Docket Number:	07-AFC-06C
Project Title:	Carlsbad Energy Center - Compliance
TN #:	202839
Document Title:	SDAPCD Data Response Set 2
Description:	N/A
Filer:	Dee Hutchinson
Organization:	Locke Lord LLP
Submitter Role:	Applicant Representative
Submission Date:	7/29/2014 9:38:27 AM
Docketed Date:	7/29/2014

Subject: ATC Application for Amended CECP

On behalf of Carlsbad Energy Center LLC, Sierra Research is pleased to submit the following responses to the information requested in Section B of the SDAPCD's May 29, 2014 letter regarding the Authority to Construct (ATC) application package for the Amended Carlsbad Energy Center Project (CECP).

**Figure 5-1-1
Sample Port Layout**

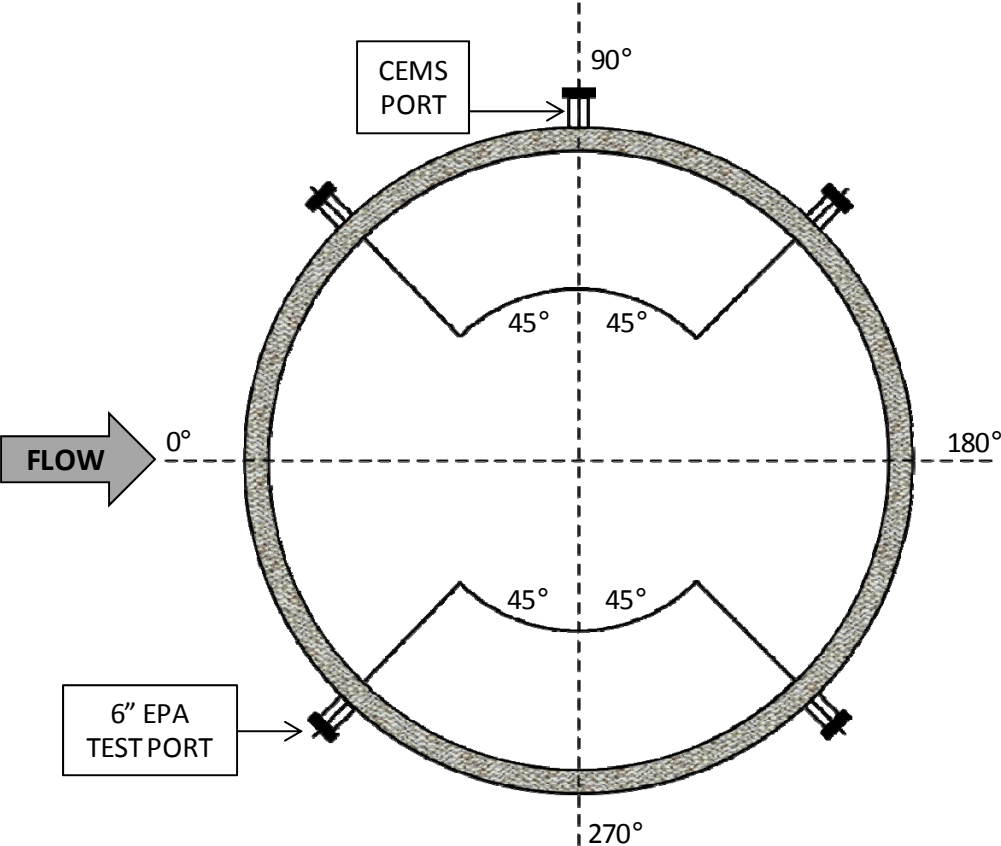
Request 5: A detailed drawing(s) of the stack showing proposed location of the continuous emission measurement system (CEMS) probe(s) and sample ports for source testing in the stack. The drawing(s) should be sufficiently detailed to indicate any potential flow disturbances in the stack resulting from turning, expanding, or contracting of the exhaust flow.

Response: The drawings showing the locations of the CEMS probe and source test sample ports are provided in Attachment 5-1.

Encina CO Catalyst Conversion vs Temperature New and 20,000 Hours

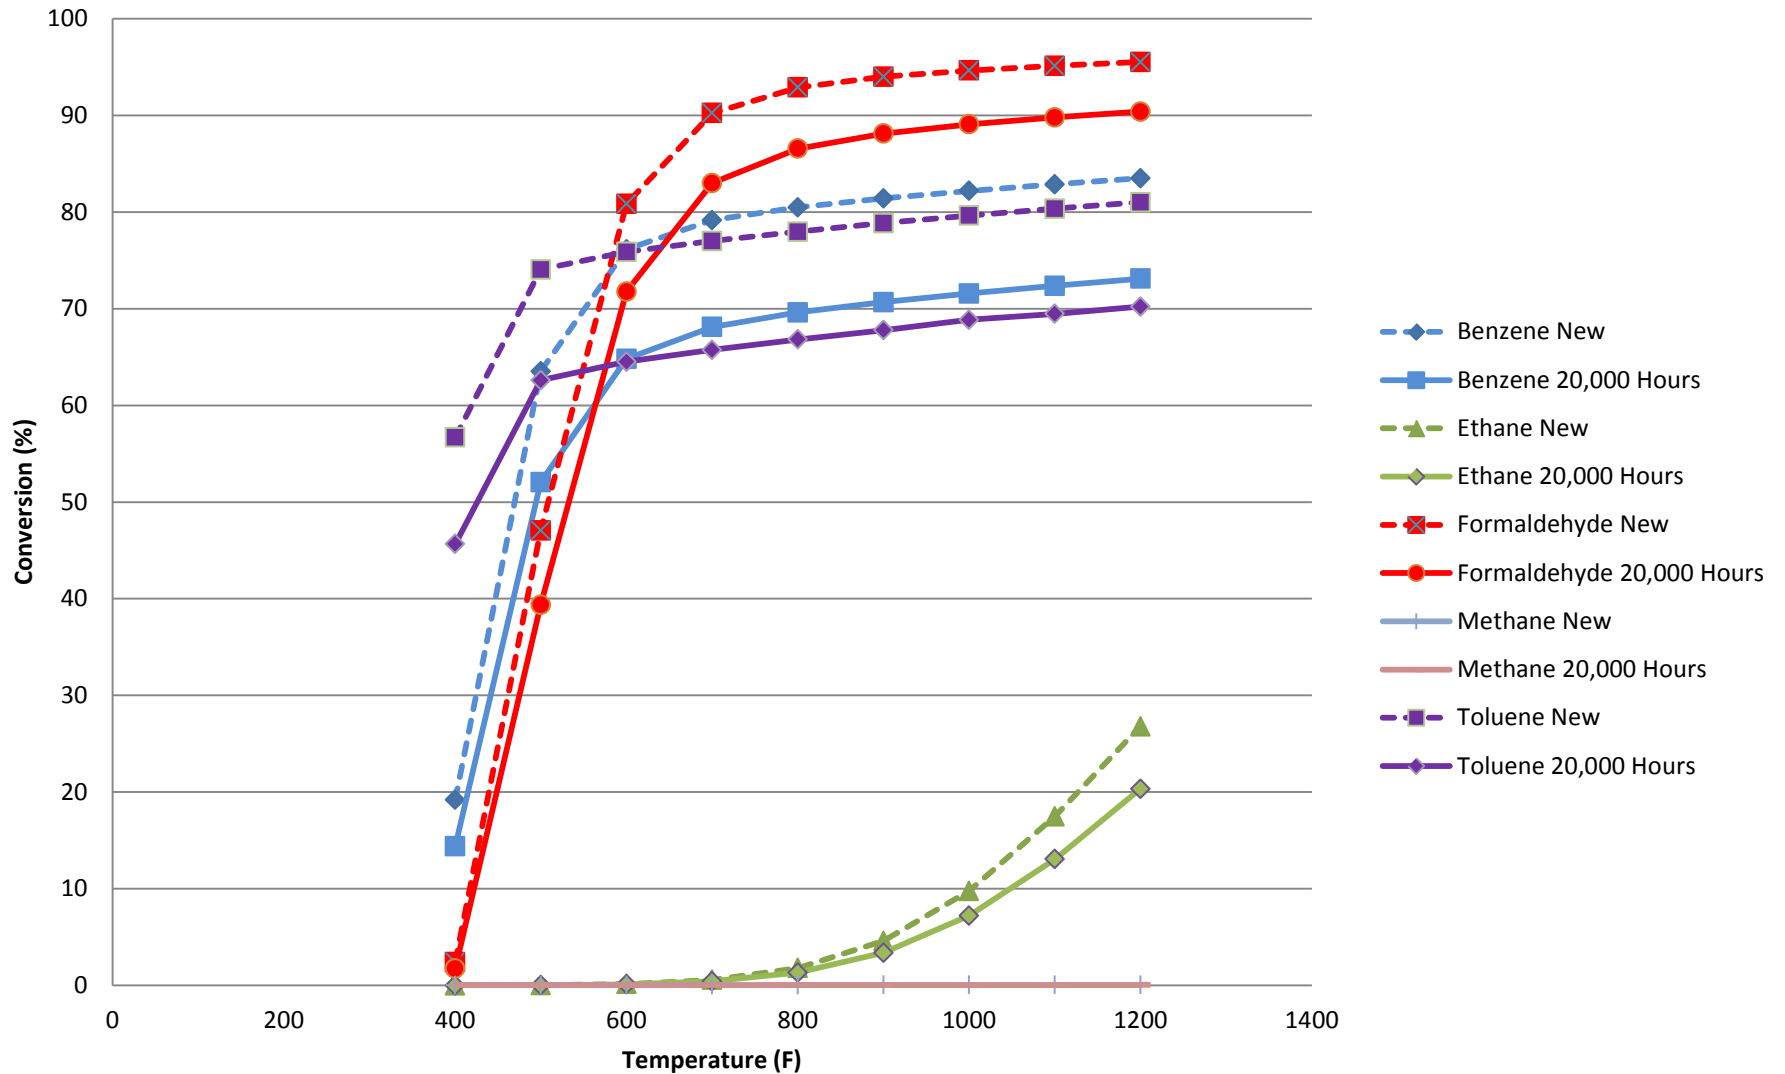
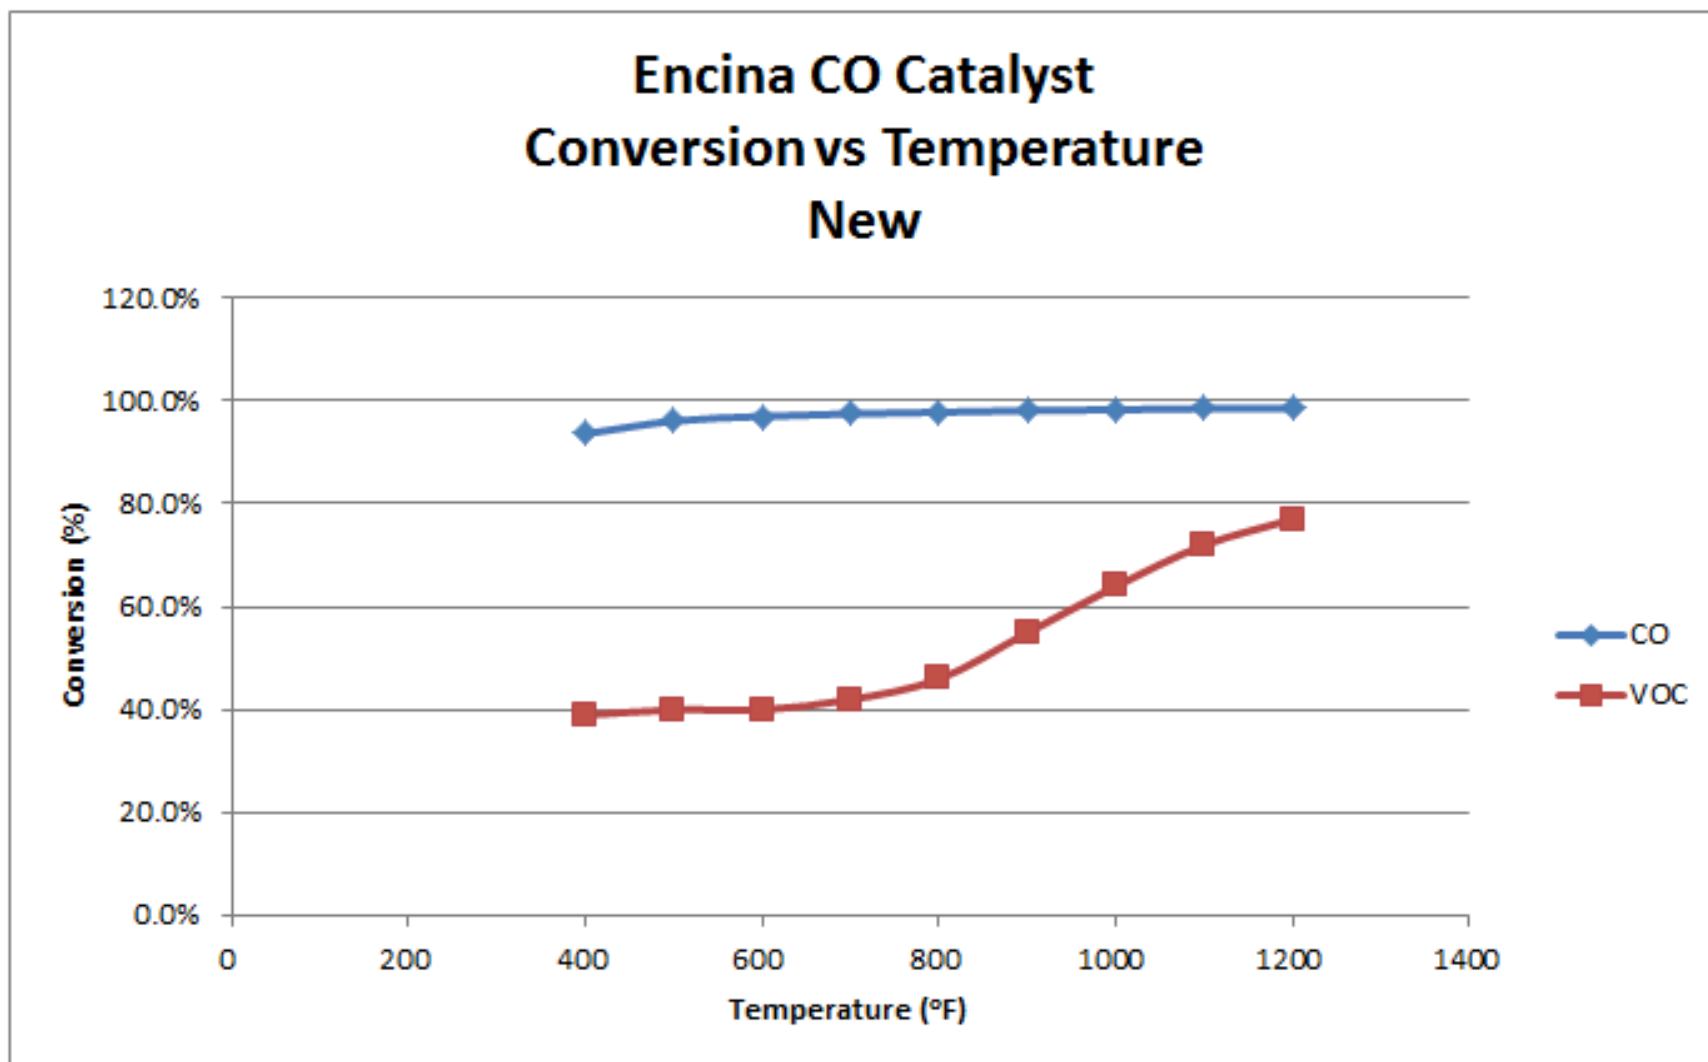
Request 6: The preliminary oxidation catalyst volume and space velocity during normal operations at 100% load and 25% load and the expected control efficiency versus catalyst temperature for CO, methane, ethane, propane, formaldehyde, and benzene or toluene at those space velocities both when new and after 20,000 hours of operation (or at the recommended catalyst replacement age, if sooner).

Response: According to General Electric, the oxidation catalyst volume will be approximately 109 cubic feet and the space velocities at 100% load and 25% load will be approximately 227,000 1/hr and 57,000 1/hr, respectively. Graphs provided by General Electric showing the expected control efficiencies versus oxidation catalyst temperature are included in Attachment 6-1.
